Preliminary and Final DRAINAGE PLAN AND REPORT

ROCKY TOP MOTEL AND CAMPGROUND

County File No.: PPR2140

Drainage Report - Final_V3.pdf Markup Summary

National Flood Hazard Layer FIRMette

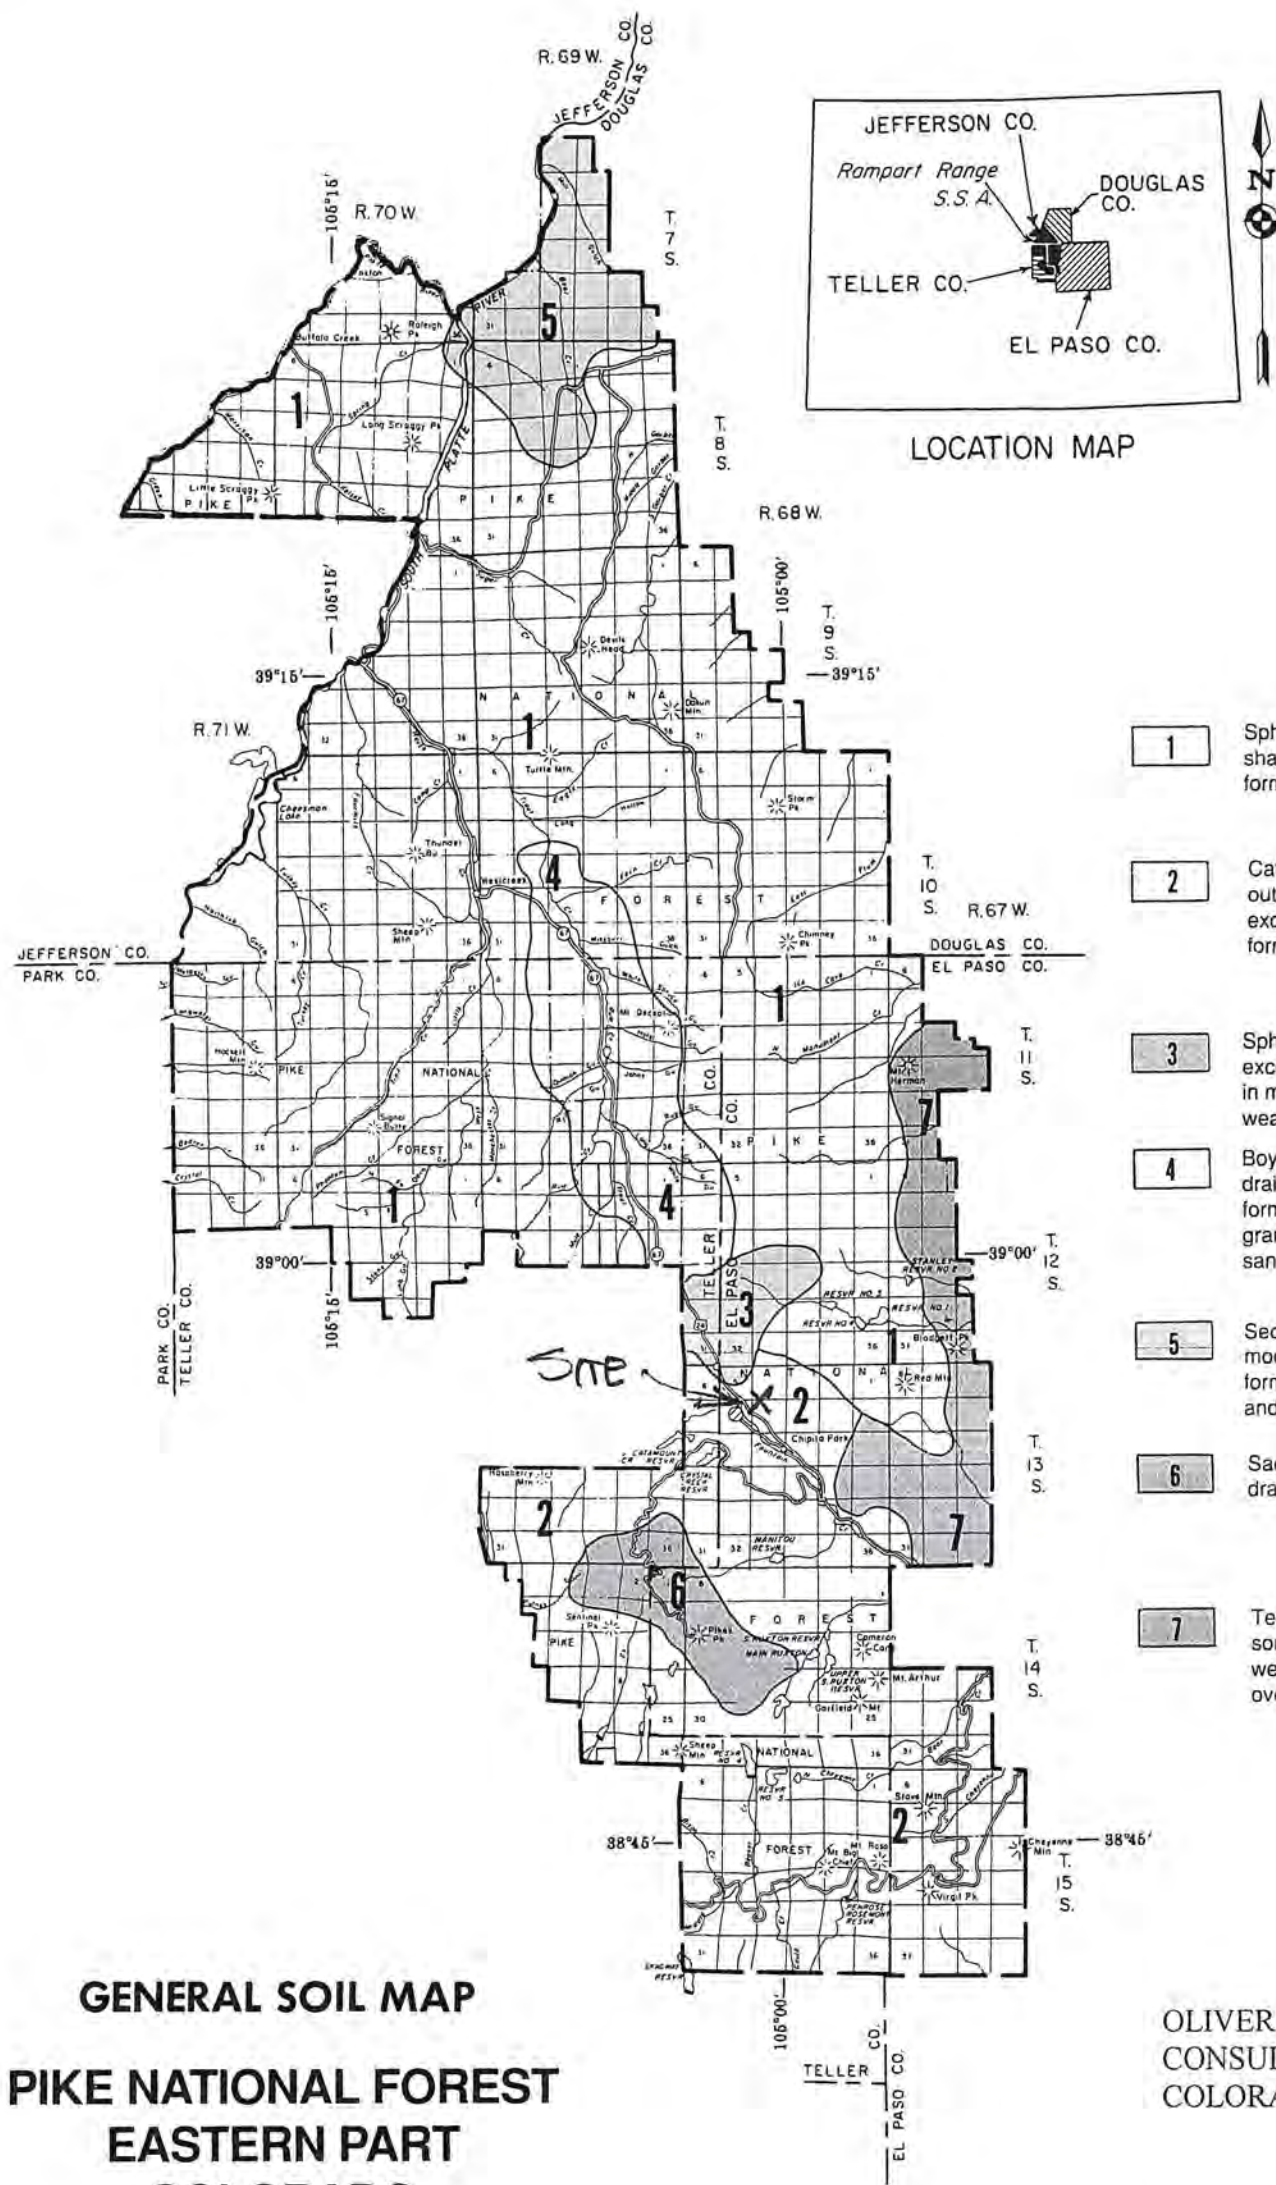
Review 3 comment: As indicated on the previous review comment, please revise your FIRM# per your attached FIRM Map (08041C0467G)
Review 4: unresolved.

review 3: zone D per the FIRM map.
Please revise
Review 4: Unresolved

DRAINAGE PLAN

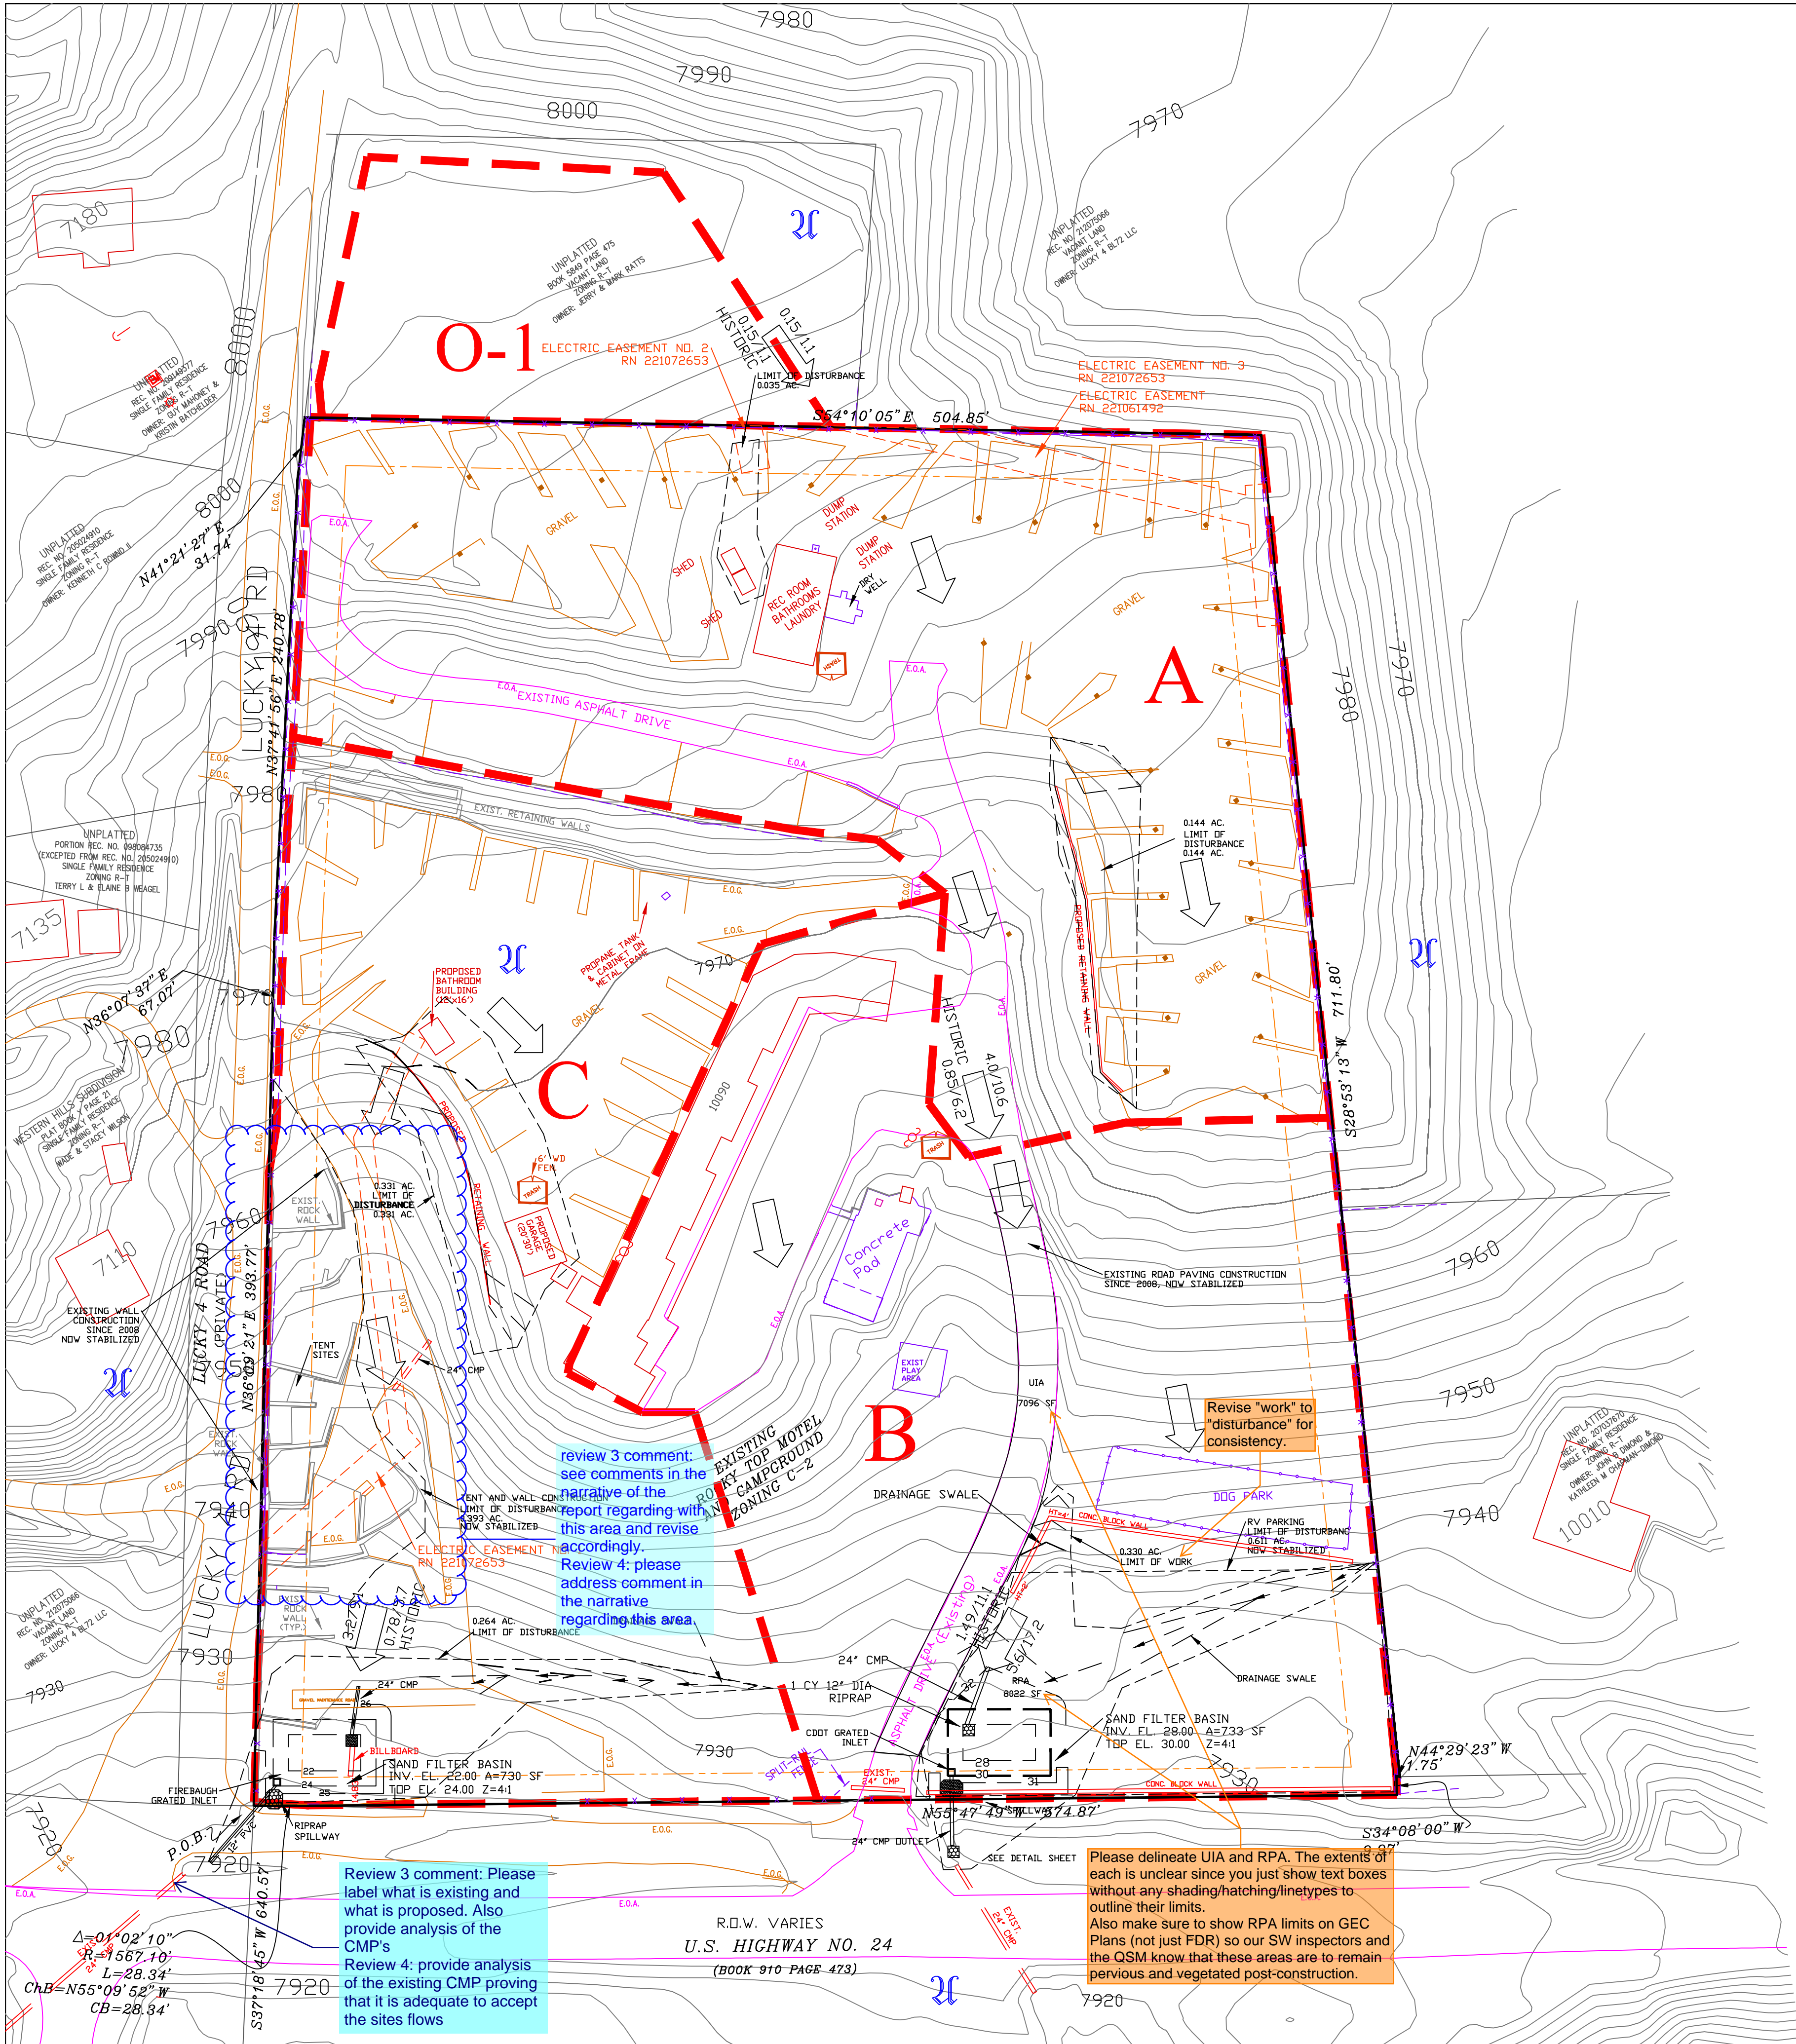
Other notes to address in report text and/or as callouts on this drainage map and in GEC Plans for runoff reduction:

- RPA vegetation should be turf grass (from seed or sod)
- Turf grass vegetation should have a uniform density of at least 80%.
- Show suitability of topsoil of RPA and steps for proper preparation of RPA soil per recommendations in MHFD detail T-0.
- Irrigation (temp or permanent) is necessary to establish sufficient vegetation and not just weeds.

Review 3 comment: Please label what is existing and what is proposed. Also provide analysis of the CMP's
Review 4: provide analysis of the existing CMP proving that it is adequate to accept the sites flows

review 3 comment: see comments in the narrative of the report regarding with this area and revise accordingly.
Review 4: please address comment in the narrative regarding this area.

Please delineate UIA and RPA. The extents of each is unclear since you just show text boxes without any shading/hatching/linetypes to outline their limits.
Also make sure to show RPA limits on GEC Plans (not just FDR) so our SW inspectors and the QSM know that these areas are to remain pervious and vegetated post-construction.

WEST SFB DETAILS

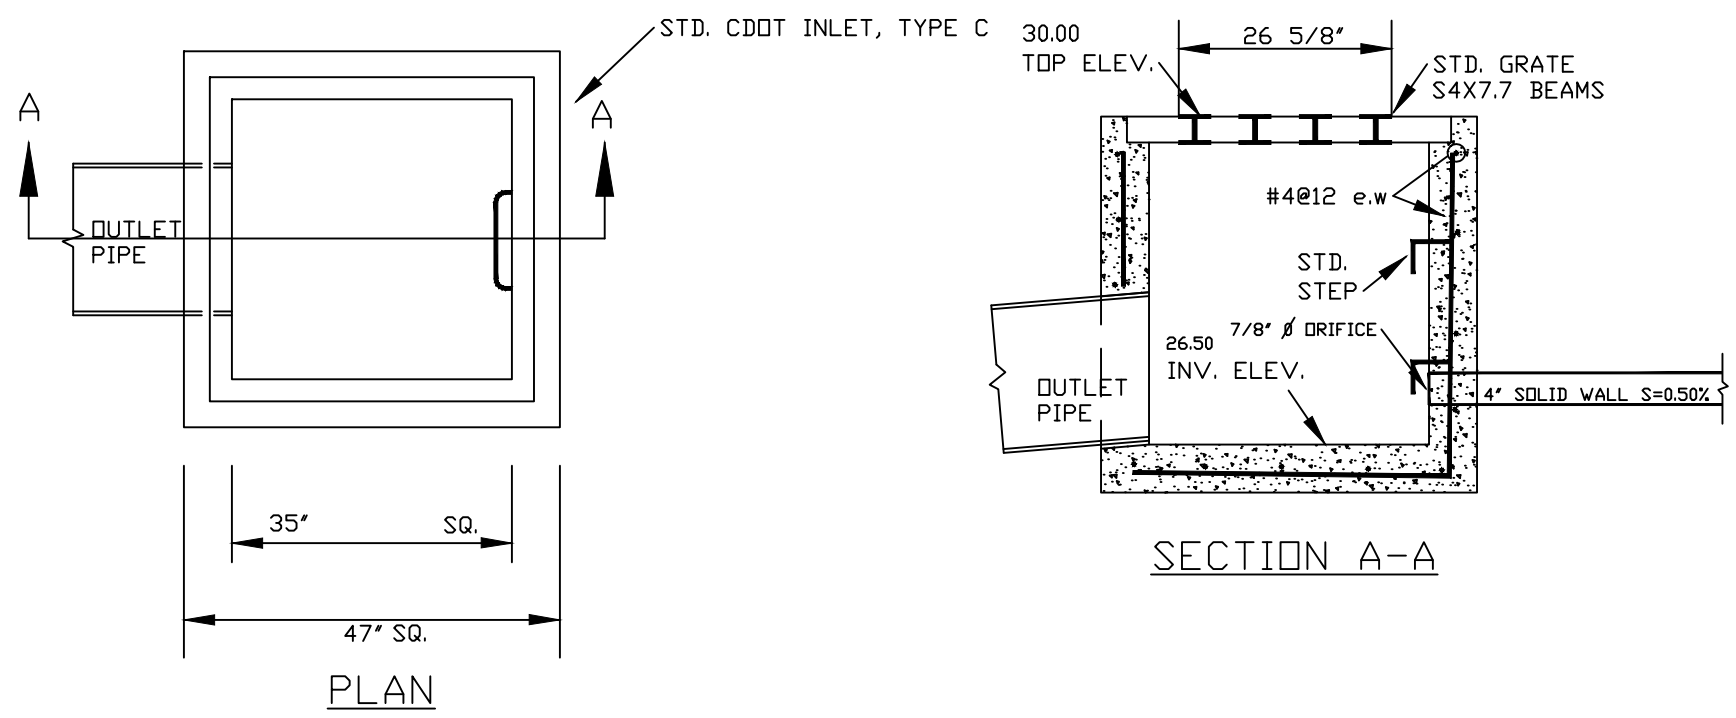
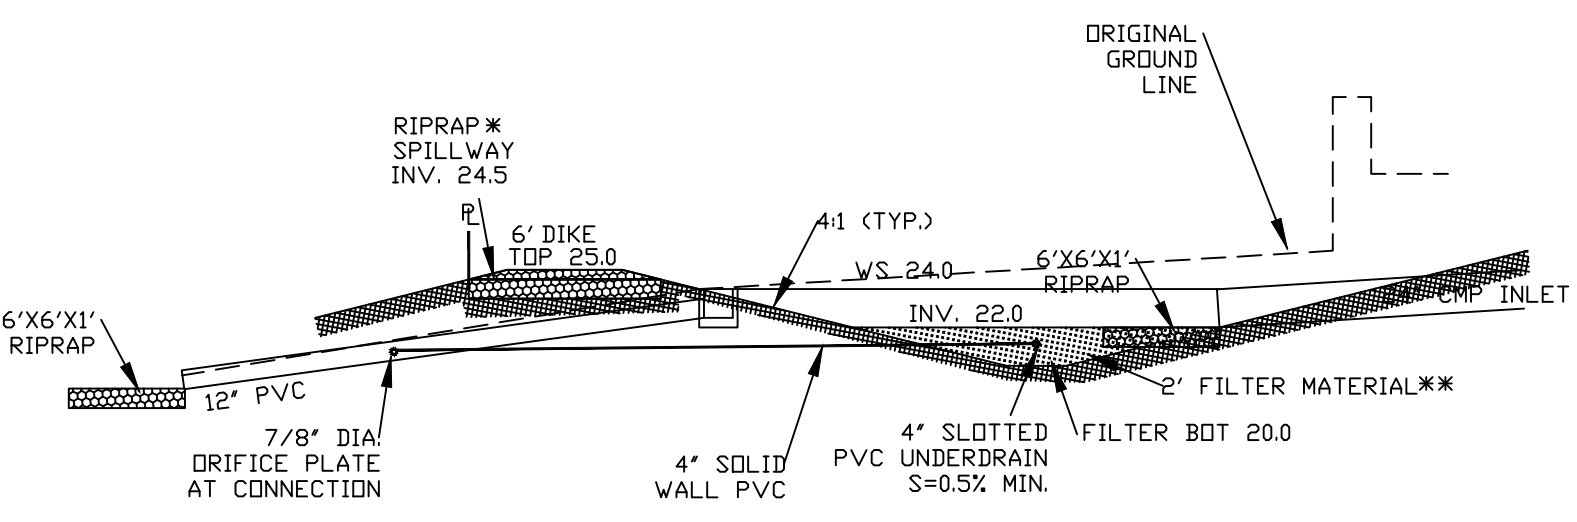
Also complete the MHFD UD-Detention worksheet to show change from existing to proposed flows and to calculate the orifice hole dimensions in the outlet. Currently shown on plans as 7/8" but no calcs provided to support that.

Also complete the MHFD UD-Detention worksheet to show change from existing to proposed flows and to calculate the orifice hole dimensions in the outlet. Currently shown on plans as 7/8" but no calcs provided to support that.
